MEMORANDUM

TO: Joint and Common Market
FROM: David B. Patton, Michael Wander
DATE: May 24, 2016
RE: Comments on Pseudo-Time Impacts and Alternative Firm Capacity Delivery Procedures

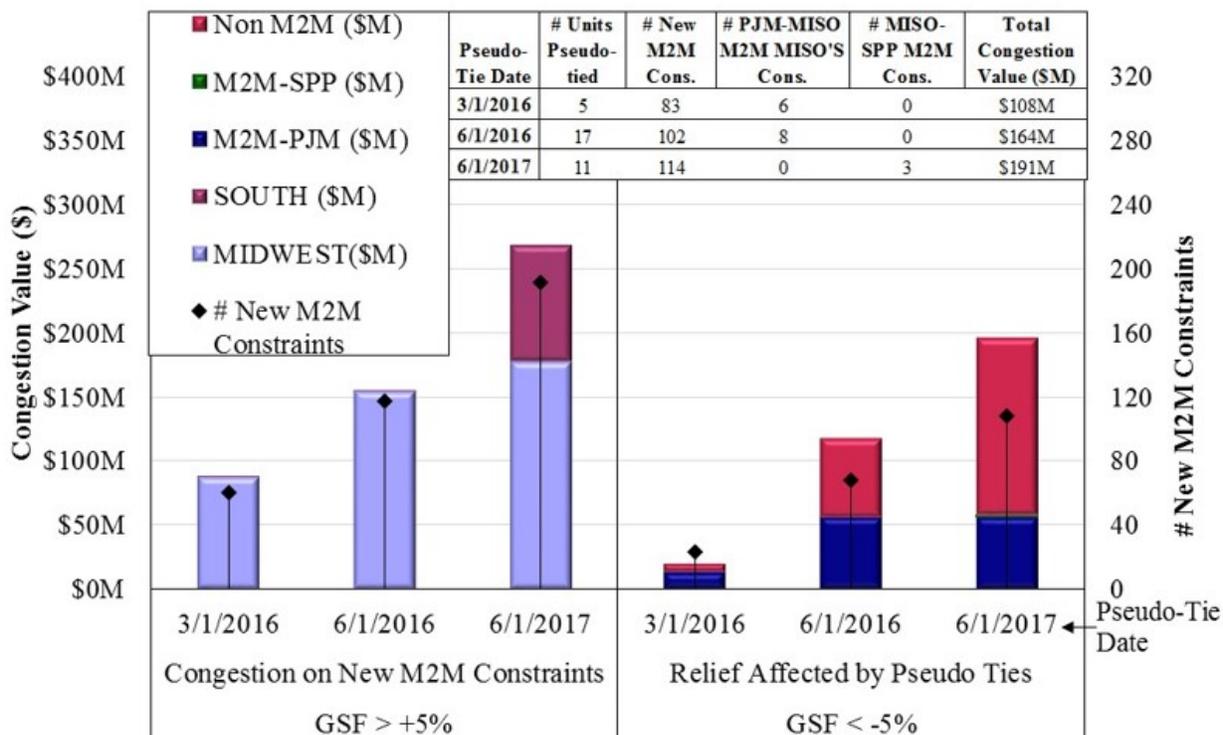
Based on our analysis shown in figure below, more than 300 MISO non-M2M constraints that bound in 2015 will now need to be defined as market-to-market constraints so they can be coordinated. This will occur because units located on MISO’s transmission system will be under the dispatch control of PJM so the flows they cause on MISO’s constraints will now become PJM’s market flows and the market-to-market process will be necessary to manage these flows. Unfortunately, the market to market coordination is not nearly as effective as full dispatch control and many of the constraints will remain non-market to market constraints. This is a serious issue because the figure also shows that the value of the congestion on these constraints exceeded \$400 million in 2015, roughly 30 percent of all MISO congestion.

The left panel of the figure shows the constraints that the pseudo-tied units load and the right panel shows the constraints that they unload. The drop line in each panel shows the number of new MISO constraints in each class that will now qualify as market-to-market constraints while the bars show the value of the real-time congestion on the constraints. Finally, the data is divided to show the effects of each of the groups of resources that have or are pseudo-tying to PJM on March 2016, June 2016, and June 2017.

This figure shows that the constraints and associated congestion in 2015 that would be affected by the pseudo-tied resources is large. The value of the congestion affected by the pseudo-ties will rise in the future if gas prices rise and/or if congestion becomes more poorly managed because of the pseudo-ties.
